Re: Construction Service Commission Follow-up

The Construction Service Commission workgroup met at AGC Headquarters on Wednesday, September 23rd for the second time to review previously submitted proposed changes to rule R156-55a.

FIGURE AF102
RADON-RESISTANT CONSTRUCTION DETAILS FOR FOUR FOUNDATION TYPES

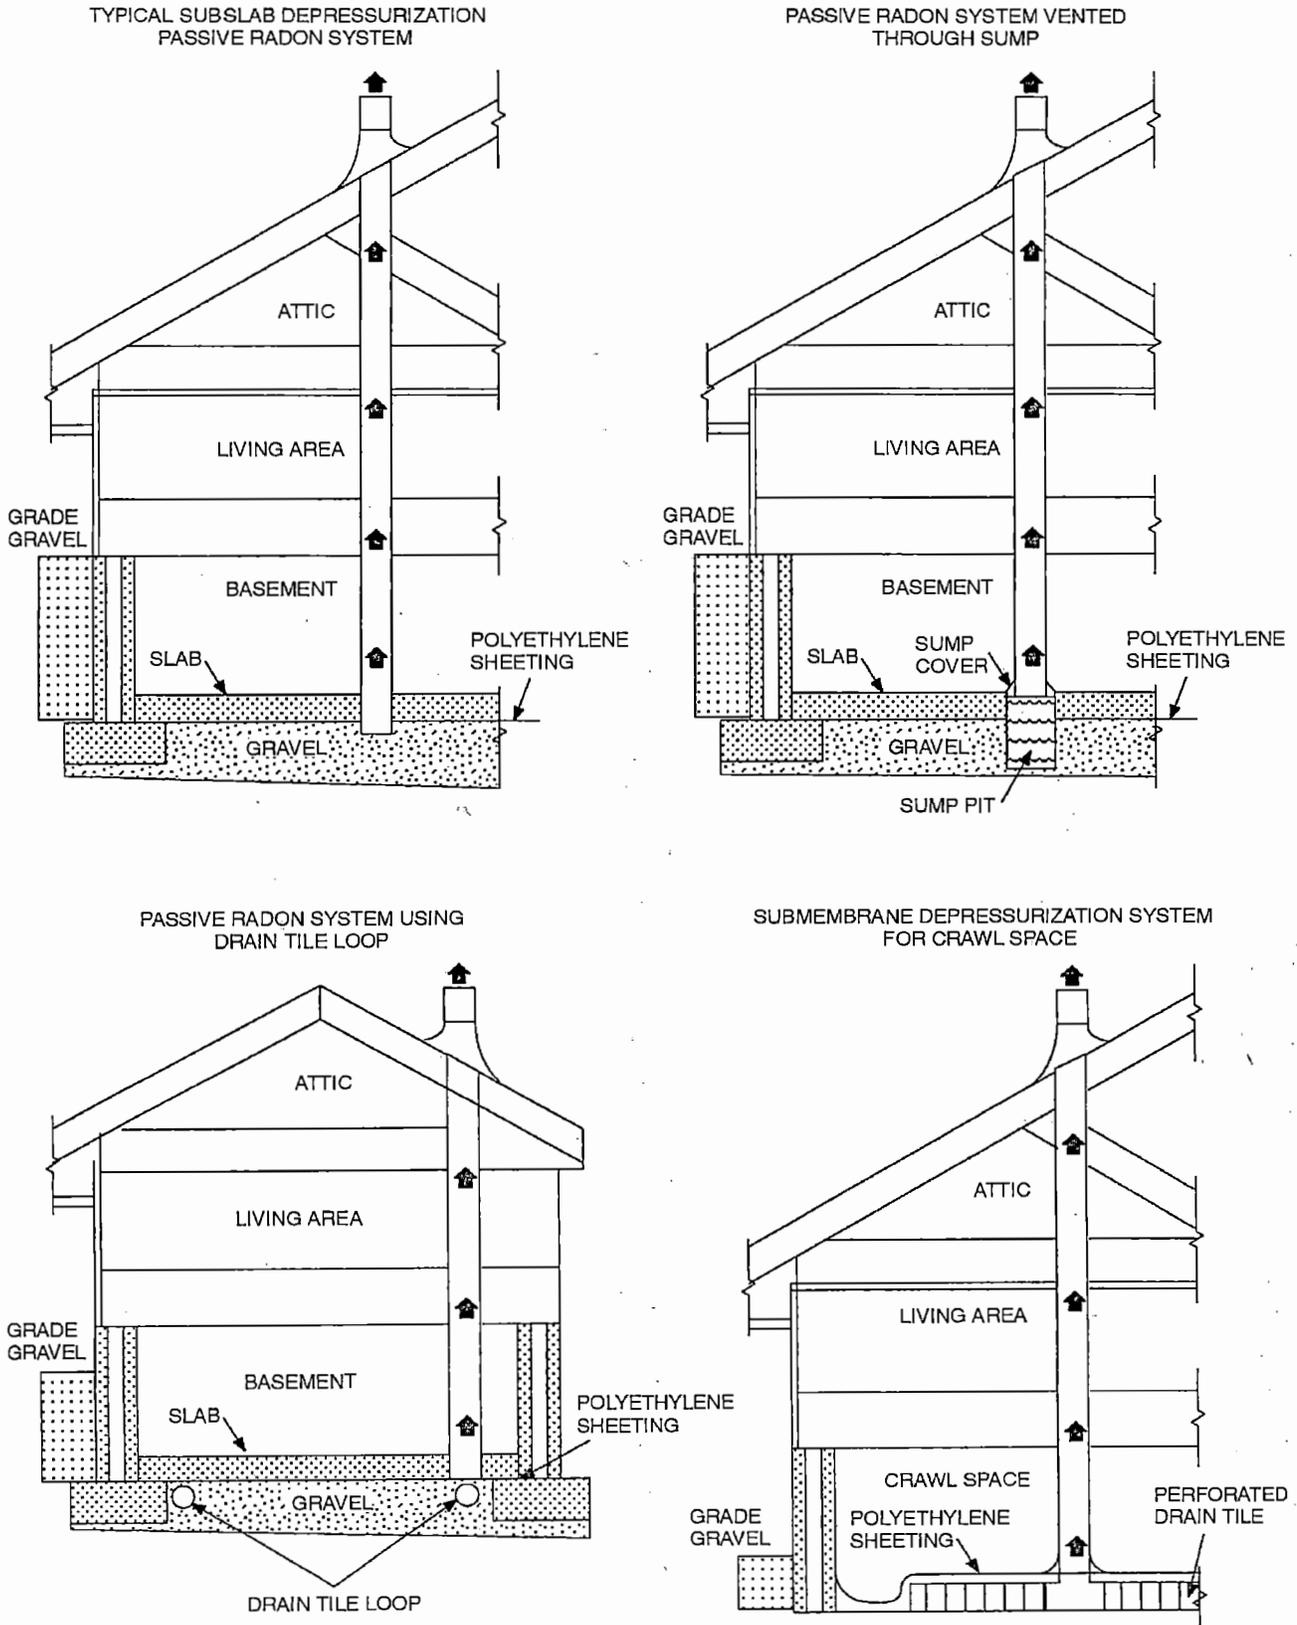
The Home Builders Association of Utah would like to propose we strike R156-55a-301(2)(b)

(b) The General Building Contractor scope of practice does not include activities described in this Subsection under specialty classification S354-Radon Mitigation Contractor unless the work is performed under the immediate supervision of an employee who holds a current certificate issued by the National Radon Safety Board (NRSB) or the National Radon Proficiency Program (NEHA-NRPP).

As building science improves our ability to build extremely tight homes it increases the possibility of Radon gas build up. According to the International Residential Building code "Radon gas is a naturally occurring, chemically inert, radioactive gas." It is impossible to test for this gas prior to construction but is easily mitigated during construction. Appendix F of the IRC provides specific directions for the installation of passive radon gas controls. Once construction is complete the structure can be tested, if it is found to have radon gas build up the passive system can be converted over to an active system with the simple installation of a small fan.

The Home Builders Association believes the industry should constantly be looking for cost efficient ways to improve the homes built in Utah. The requirement for additional certification to install a simple, non-mandatory system is burdensome and discourages use.
